## **111341 - 01**

<b>Change Notification #:</b>	<b>111341 - 01</b>
<b>Change Title:</b>	<b>Intel Ethernet Server Adapters I350-T2/T4/F4, Stony Lake Retail/OEM generic</b> <b>PCN 111341-01</b> <b>Product Design, Label, Product Material</b> <b>Capacitor Change and EEPROM Image Update from .93 to 1.63, Add flyer, Add EPC / EAN #s, Remove CDA (retail only)</b> <b>Reason for Revision: Include additional items and new implementation date.</b>
<b>Date of Publication:</b>	<b>December 14, 2012</b>

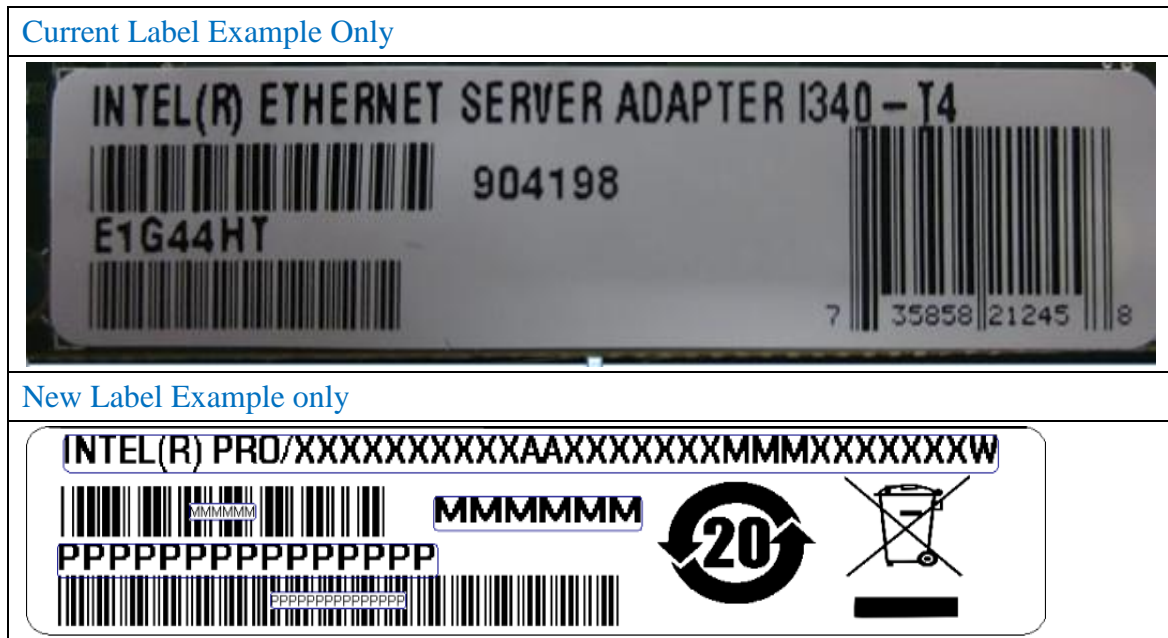
3. Remove CDA from all Retail SKUs (I350F4, I350F4BLK, I350T2, I350T2BLK, I350T4, I350T4BLK).
4. Replace existing China RoHS flyer with new flyer on OEM SKUs (I350T2G1P20, I350T4G1P20). Add new China RoHS flyer to all Retail SKUs (I350F4, I350F4BLK, I350T2, I350T2BLK, I350T4, I350T4BLK)

关于符合中国《电子信息产品污染控制管理办法》的声明  
Management Methods on Control of Pollution from Electronic Information Products  
(China RoHS declaration)

For regulatory information go to the user guide:

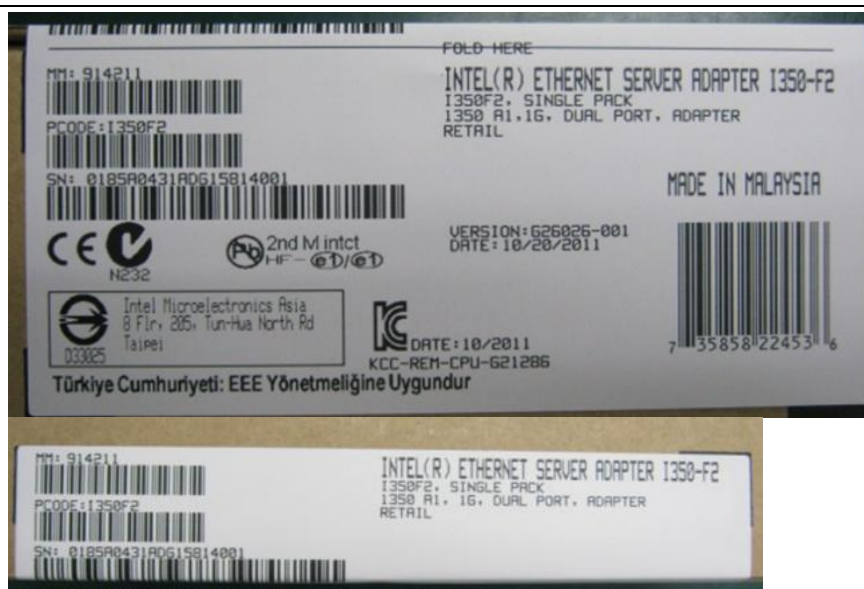
Additional fields are being added to display the outer case UPC and EAN codes for overall carton quantity. New UPC codes for individual boxes are also being added.

2D matrix label will be added for easier product information scanning.

Example of old & new disti (for overpack boxes) & outer box (for retail single boxes) labels below:

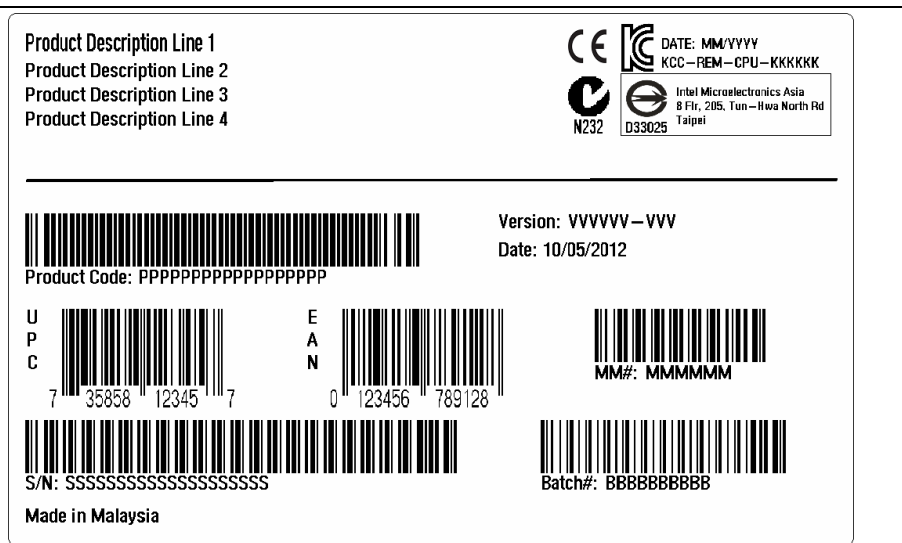
Customers should be aware that UPC and EAN codes on the outer case carton labels will be changed and that they may need to update their incoming receiving operations. Customers may receive both current and new inventory as the implementation occurs.
